July 6, 2006
L-06-114

Subject: Beaver Valley Power Station, Unit Nos. 1 and 2
BV-1 Docket No. 50-334, License No. DPR-66
BV-2 Docket No. 50-412, License No. NPF-73
Additional Information in Support of License Amendment Request Nos. 302
and 173 (Unit No. 1 TAC No. MC4645/Unit No. 2 TAC No. MC4646)

Additional Information: Long Term Core Cooling Transients for Proposed EPU Conditions (BVPS-1 & 2)

**Figure-1 BVPS-2 1.5-Inch Break, RCS Pressure/Temperature Response,
ARVs Only**

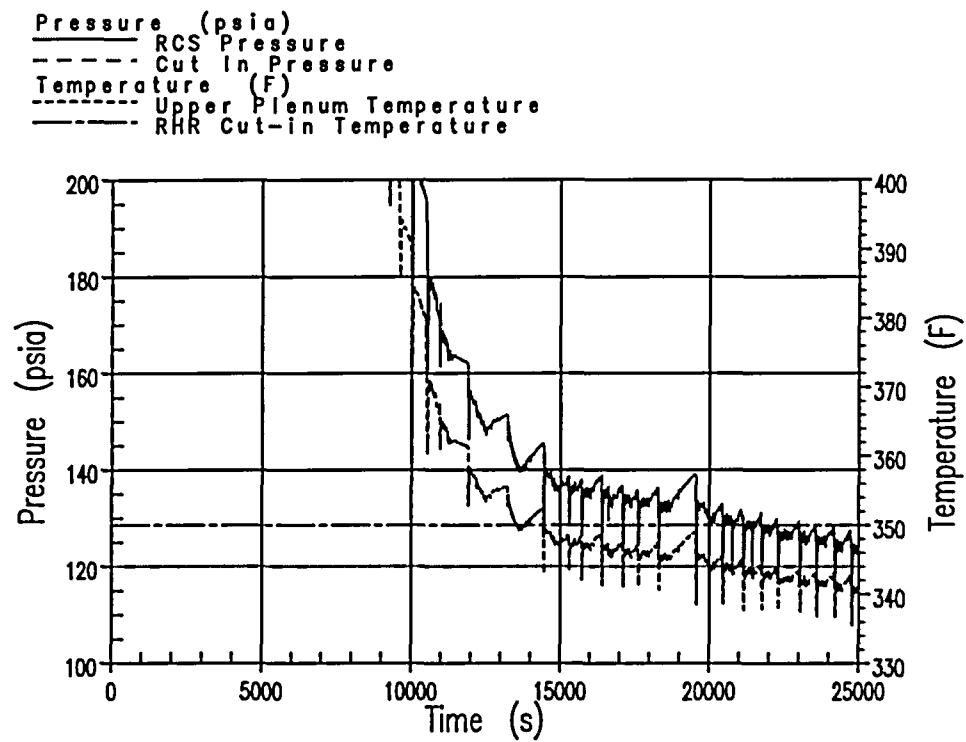
NRC review of the EPU LAR indicated that additional analysis relative to post-LOCA long term core cooling transients under the proposed EPU conditions was necessary.

The 1.5-inch cold leg break RCS cooldown and depressurization results are presented in Figure-1 and Figure-2. Figure-1 demonstrates the system response to the 1.5-inch cold leg break assuming that only the steam generator ARVs are utilized to perform the cooldown and depressurization function. As can be seen, the RCS temperature condition was achieved at approximately 14,000 seconds (3.89 hours) into the transient or 2.89 hours following the initiation of the RCS cooldown and depressurization. At 6 hours (5 hours after initiation of cooldown) the RCS had only depressurized to approximately 130 psia; therefore, in order to demonstrate acceptable depressurization to the desired RCS pressure of 120 psia, opening of the Pressurizer Power Operated Relief Valves (PORVs) is required. Figure-2 presents the same information assuming that three Pressurizer PORVs opened at 18,100 seconds (5.03 hours) to demonstrate that RCS depressurization can be achieved. As can be seen, RCS pressure can be reduced to below 120 psia approximately 600 seconds (10 minutes) after opening all three Pressurizer PORVs. The choice of 18,100 seconds to accelerate RCS depressurization using the PORVs was rather arbitrary and could have been commenced much earlier. It should be noted that even with the SG ARVs discharging and all three Pressurizer PORVs open, the RCS pressure stabilizes at approximately 110 psia under this analysis scenario. This is because the operable SG ADVs and PORVs are either under or close to critical flow conditions. If this were not the case, such as assuming either the BVPS-1 or BVPS-2 valve capacities with no failures, or assuming the availability of the condenser steam dump system, the RCS would be depressurized long before boric acid precipitation is a concern. Even under these circumstances, because of the high volume flow rates in the main steam system, RCS pressure will be slow to respond. This further reinforces the argument that no abrupt depressurization events can occur through either the ADVs or Pressurizer PORVs, thus RCS temperature remains high, promoting a very high boric acid solubility limit.
